Technical Service Bulletin: tsb101197

New Fuel Manifold Introduction

This service/parts topic introduces design changes to the QSK45 and QSK60 series engine fuel manifold, gasket, and fuel block. The failure mode associated with the current fuel manifold is wear of the steel carrier of the manifold gasket against the manifold.

Figure 1, Old and New Style Fuel Manifold

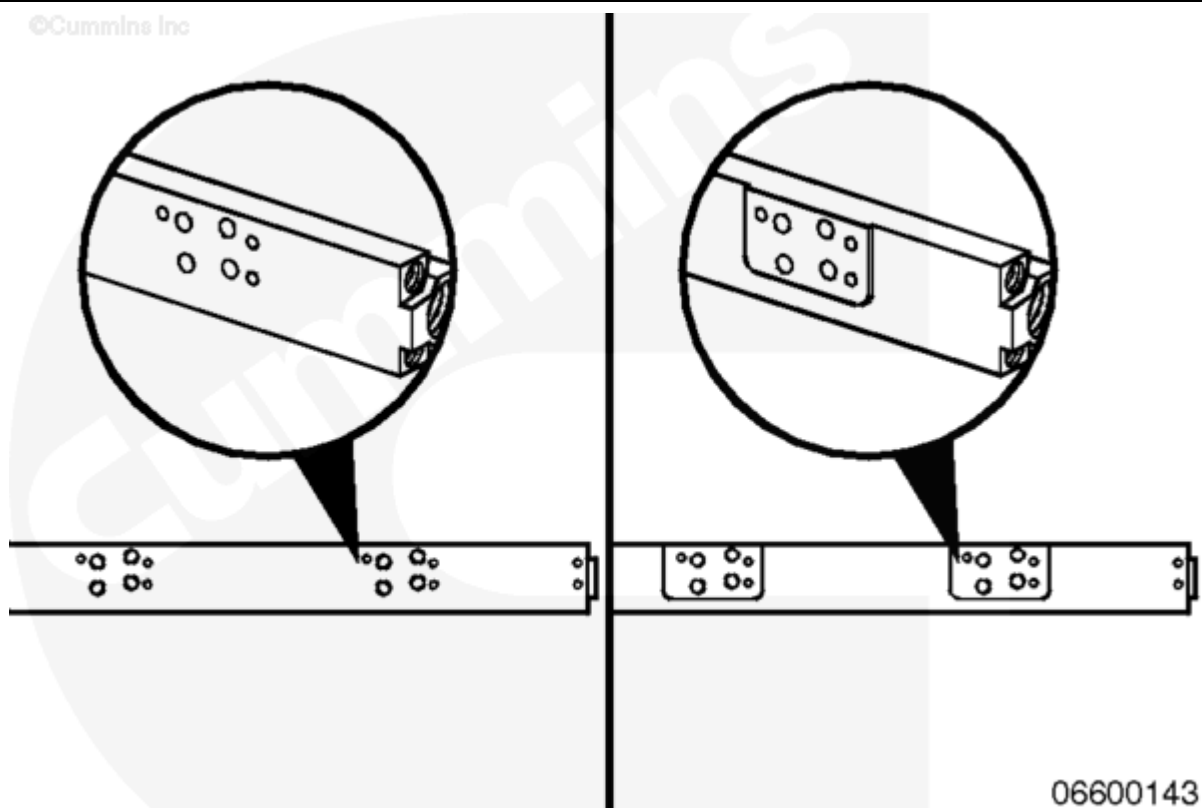
The new manifold (Figure 1, right) has raised pads to eliminate contact between the edge of the gasket and the manifold. To accommodate this change, the fuel manifold gasket and fuel block connections have also been redesigned.

Figure 2, Old and New Style Fuel Block Connection

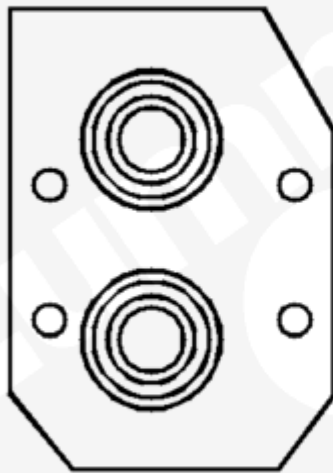
The fuel block connection did have molded-in seals (Figure 2, left). The new part number fuel block now uses two removeable o-ring seals instead of molded-in seals for improved serviceability (Figure 2, right).

Figure 3, Old and New Style Fuel Manifold Gasket

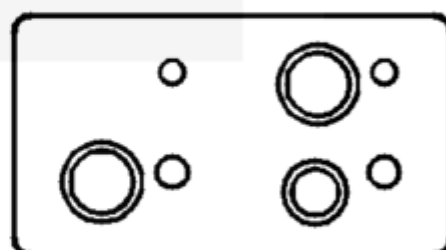
The new fuel manifold gasket (Figure 3, right) has been modified to be compatible to the pad on the new fuel manifold .
